UNITED STATES PATENT AND TRADEMARK OFFICE

10/597,913

Office Action Summary	Application No. 10/597,913	Applicant(s) UHL, GUNTER	
	Examiner SAMUEL BERHANU	Art Unit 2858

DETAILED ACTION

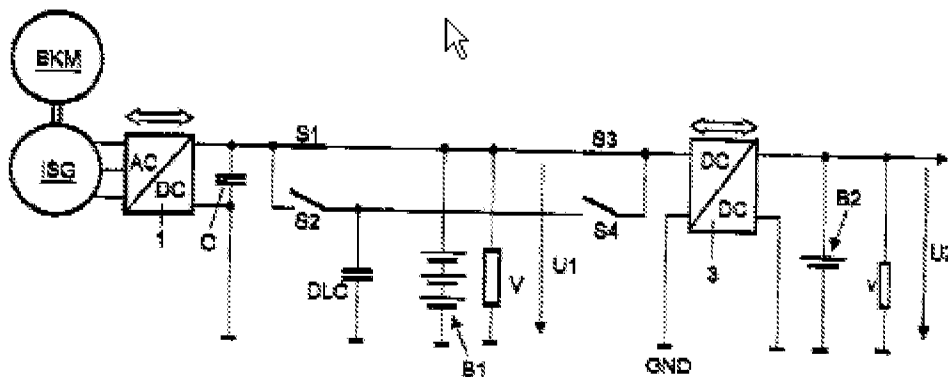
As to claims 20 and 31, Bolz discloses in figures 1-5 (see figure above), a motor vehicle electrical system, comprising:

a generator [ISG], a battery [B1], a starter and a high-capacity capacitor [DLC] for storing electric energy for the starting process of a motor vehicle engine [figure2],

a voltage transformer [DC/DC] and an interrupter [S1, S2] which are connected in parallel between the capacitor and the battery [see figure above] and which are

controlled for preparing a starting process of the motor vehicle engine in such a way that the voltage transformer transforms the voltage (UBatt) of the battery into a larger voltage [column 3, lines 58-61] and the interrupter interrupts the electrical connection between the battery and the capacity [column 8, lines 11-15].

As to claim 22, Bolz discloses in figure above, a control unit for activating the voltage transformer and for opening the interrupter [column 8, lines 11-15].

As to Claim 23, Bolz discloses in figure above, wherein the control unit effects an activation of the voltage transformer and an opening of the interrupter for a short time prior to the start of the starting process of the motor vehicle engine for charging the capacitor [Column 10, lines 5-19].

As to claim 26, Bolz discloses in figure above, wherein the control unit activates the voltage transformer and opens the interrupter in dependence on the detection of the position of the ignition key [column 10, lines 5-19].

As to claim 37, Bolz discloses in figure above, wherein the battery is electrically connected to the generator as soon as the motor vehicle engine runs by itself [column 8, lines 11-15].
